**CITY OF DALLAS**  
**LANDMARK COMMISSION**  
Monday, November 7, 2016  
**AGENDA**

**1. 1321 COMMERCE ST**

Adolphus Historic District  
CA167-044(LC)  
Liz Casso

Request 4: Site plan showing proposed light locations.

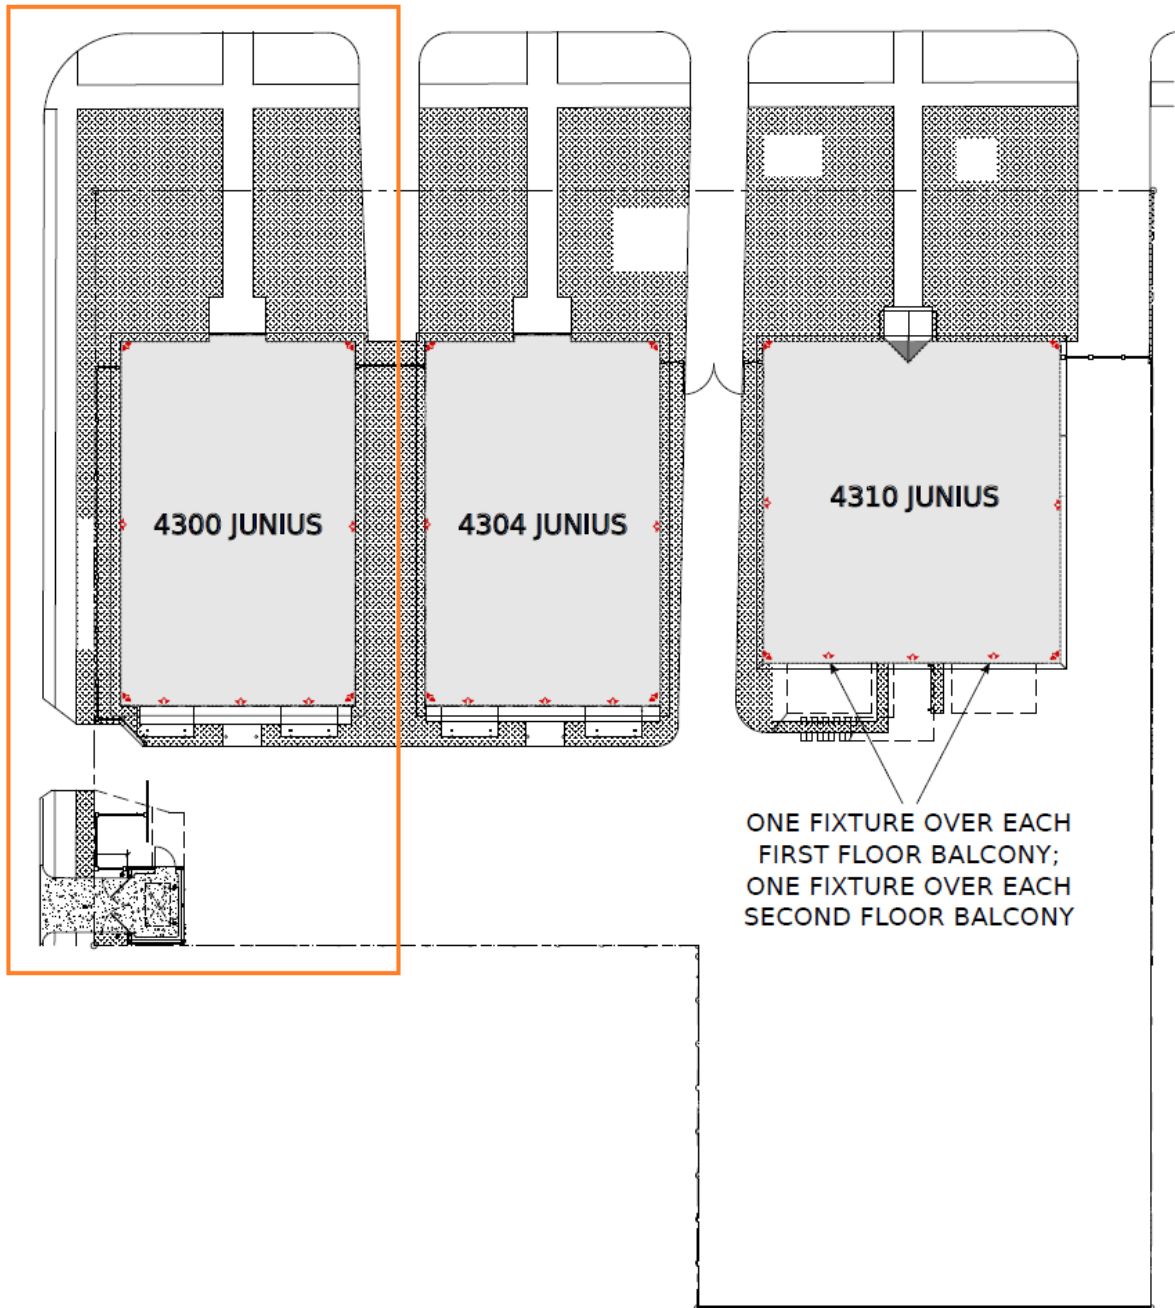
4. Install nine light fixtures on exterior of main structure. Approve with conditions – Approve site plan dated 10-6-16 with the condition that the proposed light fixtures are installed in the mortar. The proposed work is consistent with preservation criteria Section 2.5 and

1. Replace all 48 windows on structure with wood 1/1 windows and paint. Brand: Benjamin Moore. Color: PM-3 "Decorator's White". Approve with condition that the windows fit the opening and the trim is typical of the style and period.
2. Replace two sets of patio doors on rear of main structure with wood patio doors and paint. Brand: Benjamin Moore. Color: PM-3 "Decorator's White". Approve with condition that the mullions are expressed on the outside of the door.
3. Replace door on rear of main structure. Approve.
4. Install nine light fixtures on exterior of main structure. Approve with condition that the light does not impede on nearby properties and that the fixtures are mounted in mortar joints.

Proposed elevations

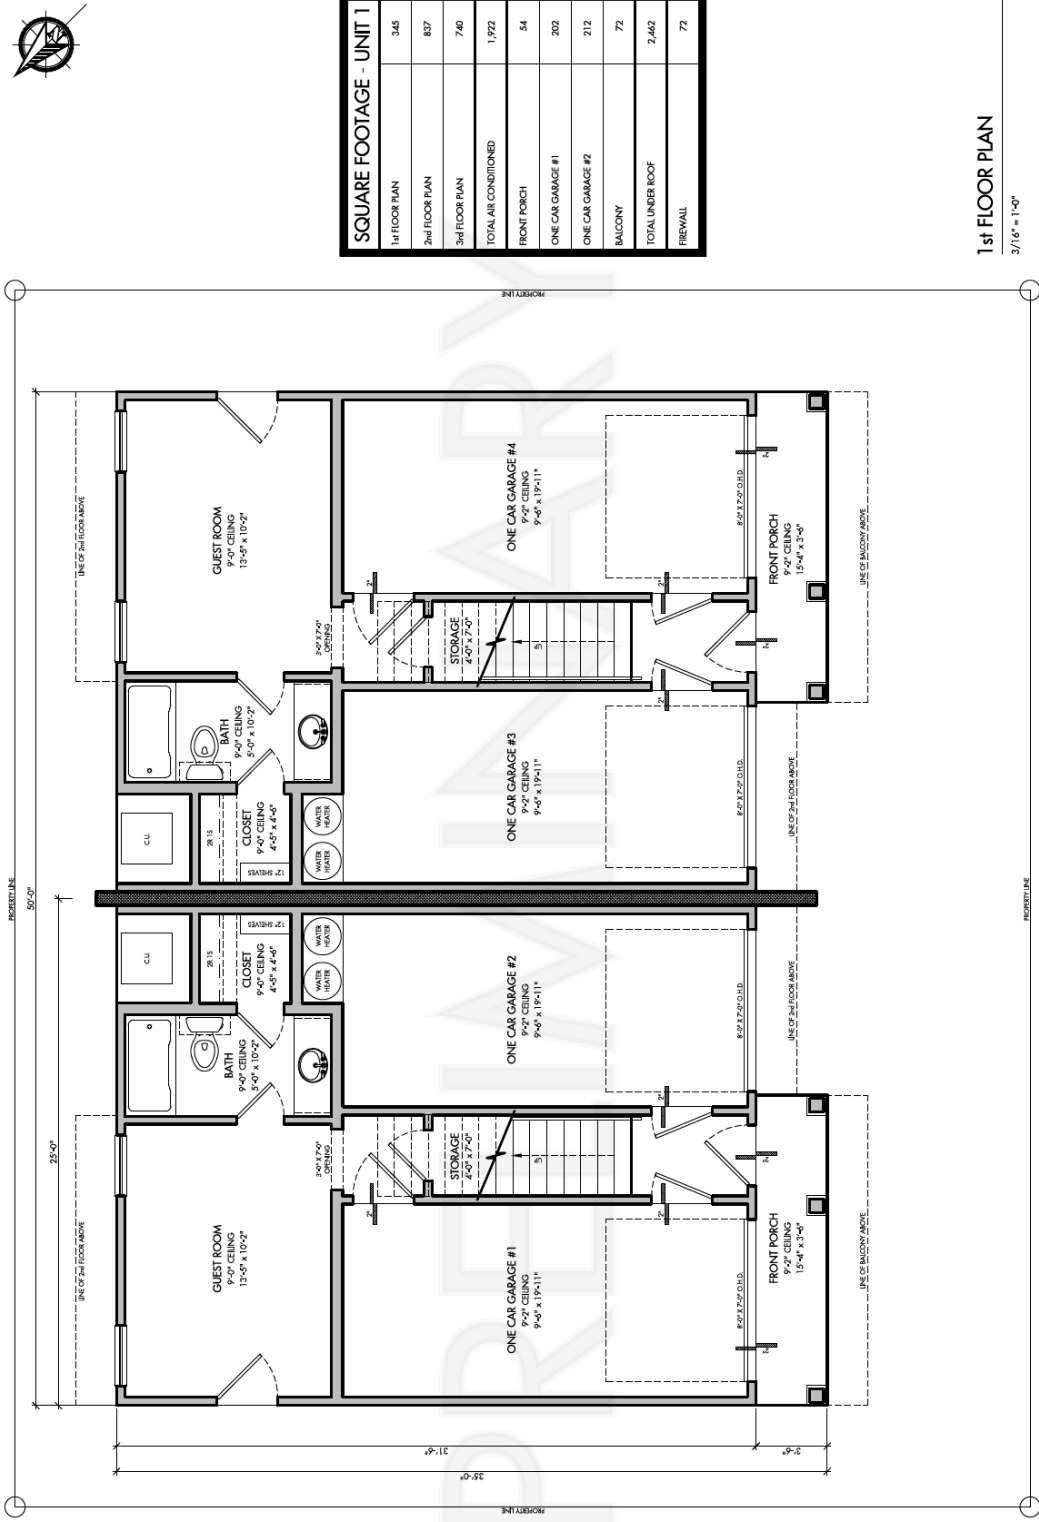
Courtesy Review - Construct duplex on vacant lot. Approve conceptually with the condition that final plans, elevations, and details are submitted for final Landmark Commission review.

Request #1 – photos submitted by applicant of houses with fences within front 50% of side yard.

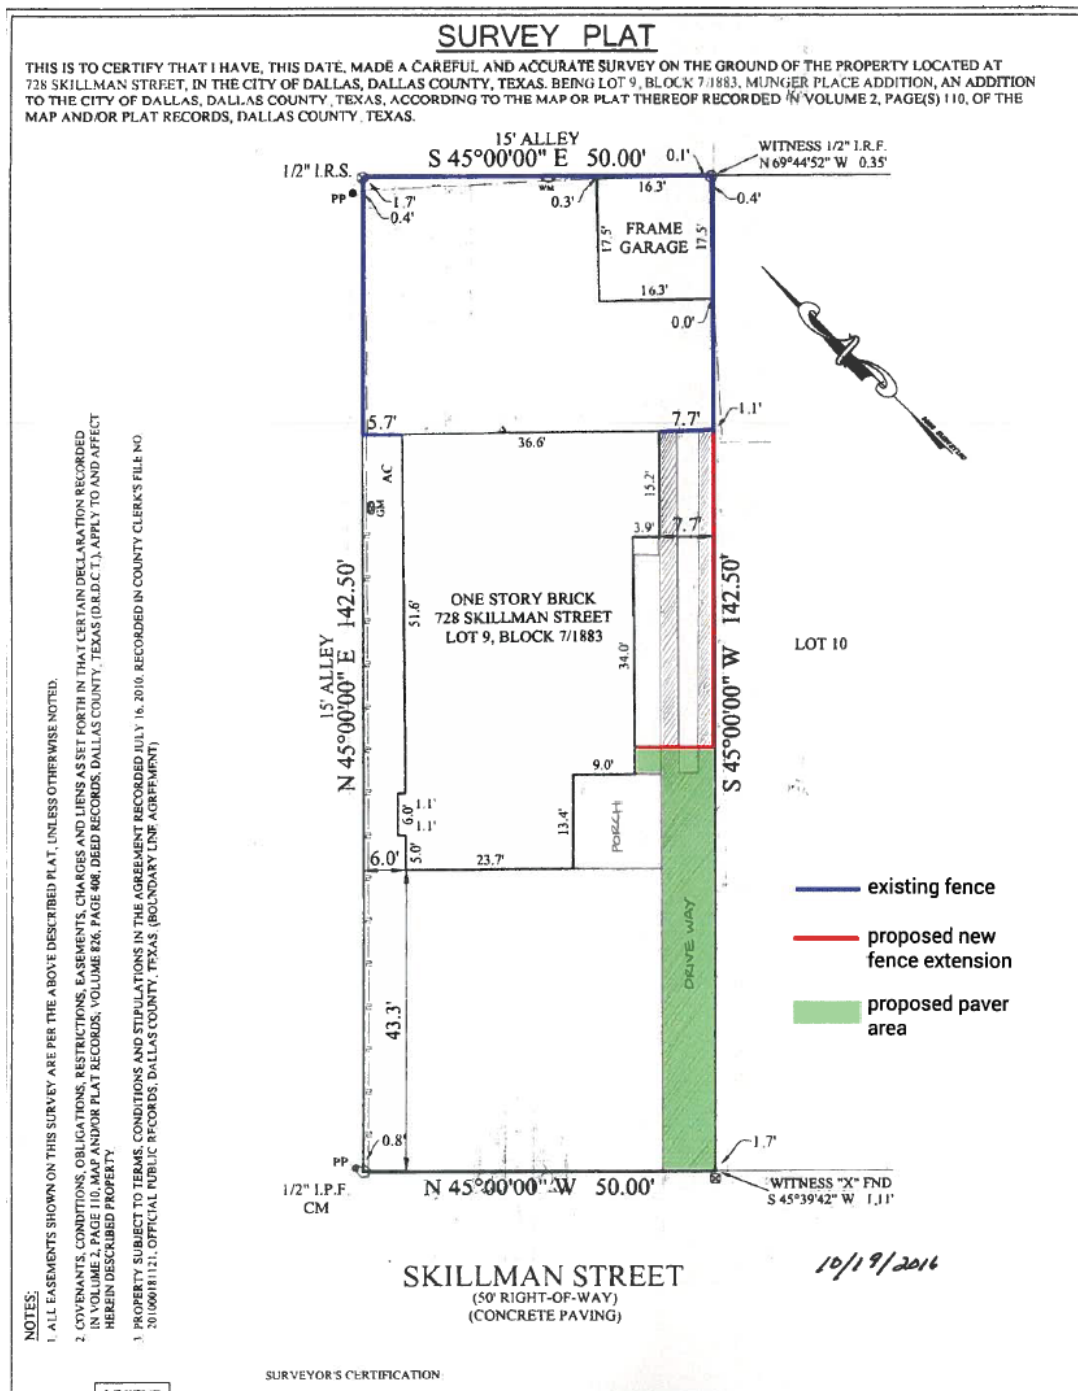
1. Extend right side yard fence into front 50%. Deny the fence extending past the rear 50% of the house (protected facade).
2. Replace front portion of concrete driveway with pavers. Deny - Driveway to be replaced with concrete per 3.2.
3. Remove ribbon driveway from side and rear yards. None.
